June 17, 2020
31595

RE: Dallas North Tollway Southbound Frontage Road – Change Order #5

Halff recommends the following Change Order #5 modifications to the Dallas North Tollway Southbound Frontage Road project.

CONTRACT NO. 03787-DNT-03-CN-PM SHEET 74 OF 343

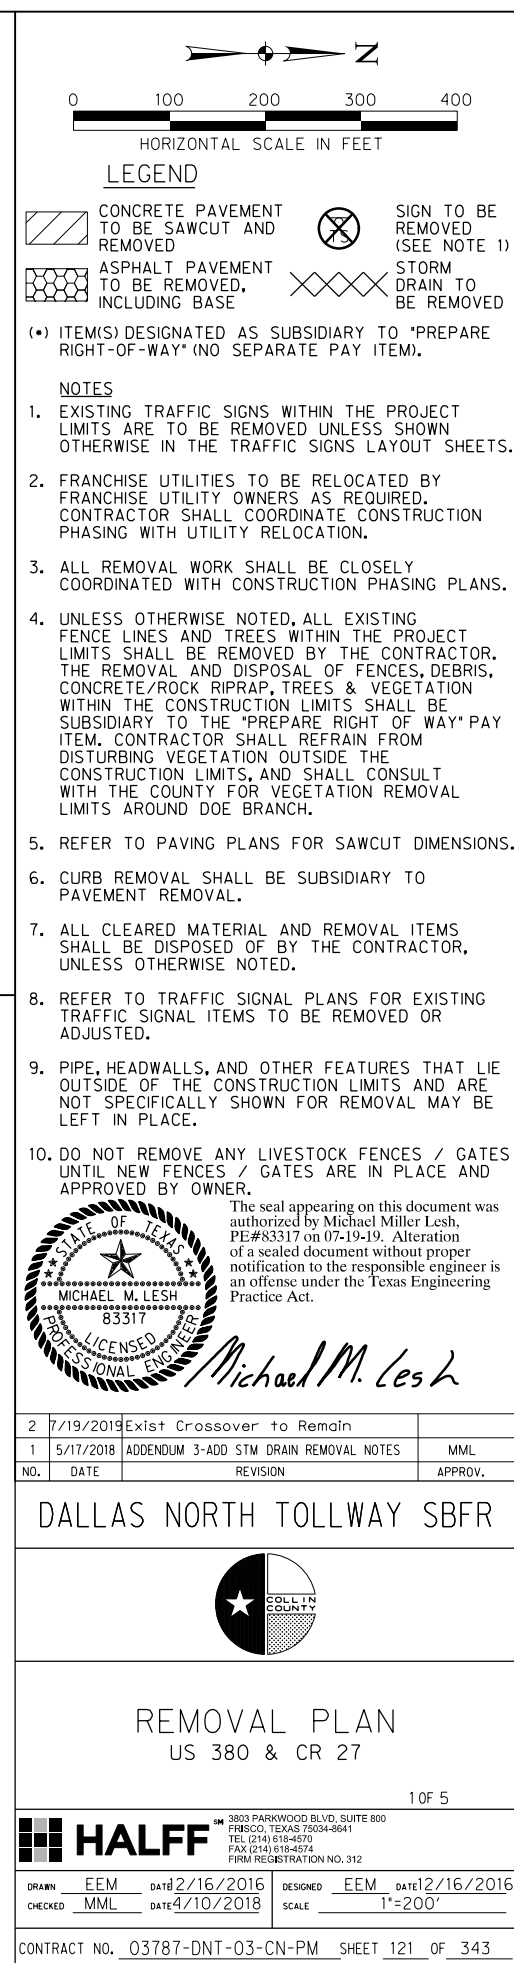
NO.	DATE	REVISION	APPROV.
1	7/19/2019	Exist Crossover to Remain	MML

These changes are due to additional RCP that the NTTA requested to be installed and are offset by a reduction of proposed pavement demolition costs that NTTA will now perform. The attached revised sheets (74, 121, 216, 218), which denote the existing crossover pavement to remain and the additional RCP, should be formally incorporated into the project documents with this change order #5.

CONTRACT NO. 03787-DNT-03-CN-PM SHEET 218 OF 343

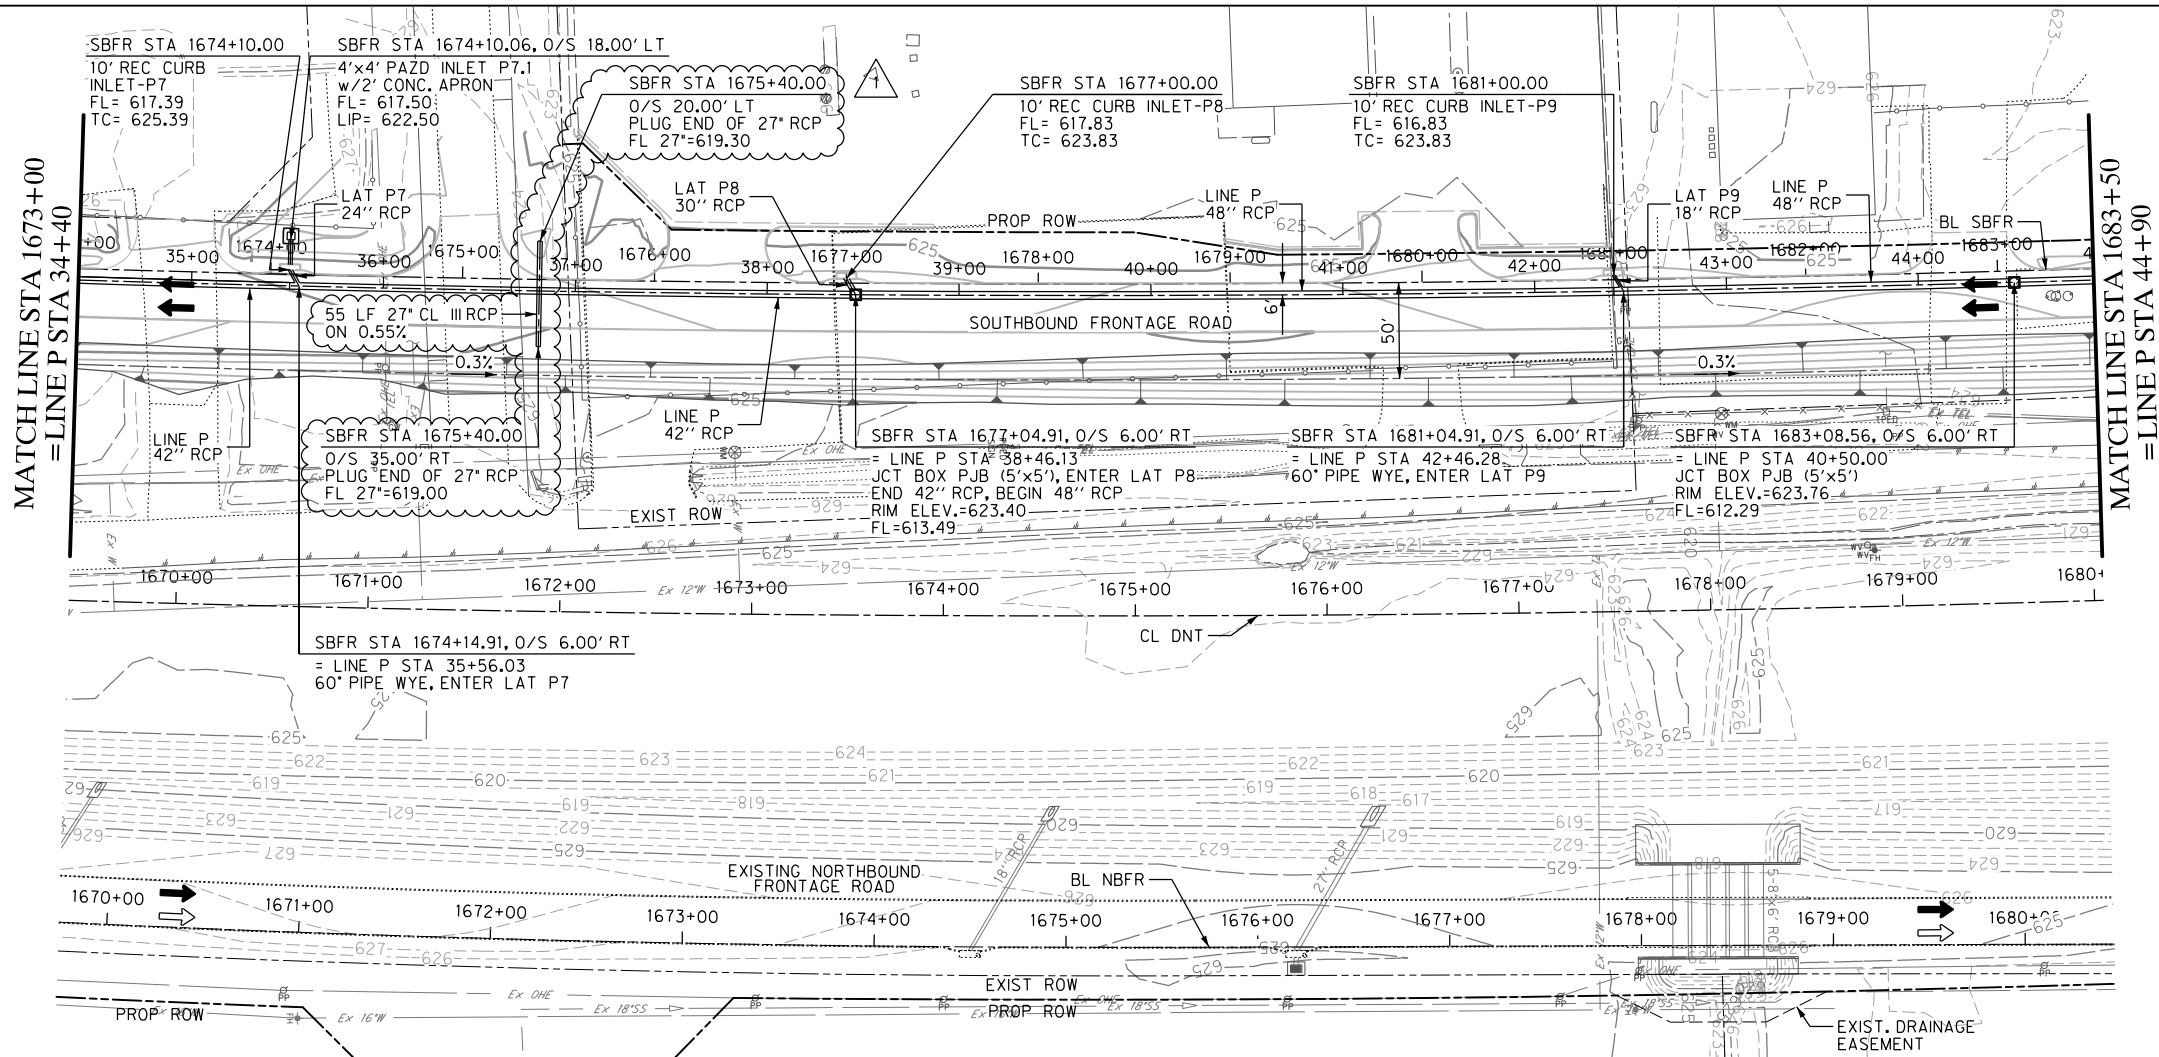
NO.	DATE	REVISION	APPROV.
1	7/19/2019	Added 27" RCP "Dry Line"	MML
